17-096ARB-INF – 113 S. HIGH STREET

Request

An Informal Review for non-binding feedback of a proposed 4,000-square-foot two-story office building and associated site improvements.

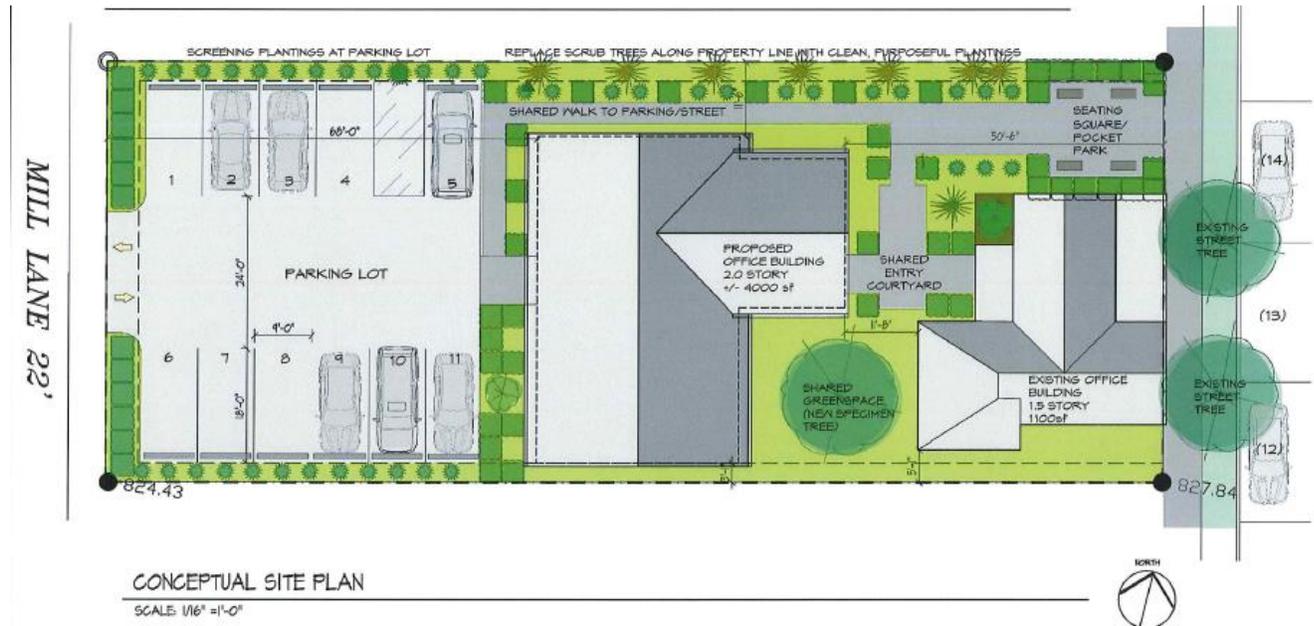
5) Mass and Scale

Several perspective views of the proposed building are included depicting the spatial relationship and the overall mass and form of the building in context with the existing buildings. The proposed two-story building is taller with a larger footprint than the existing historic structure on site. Surrounding structures fronting High Street to north and south are two-story buildings.
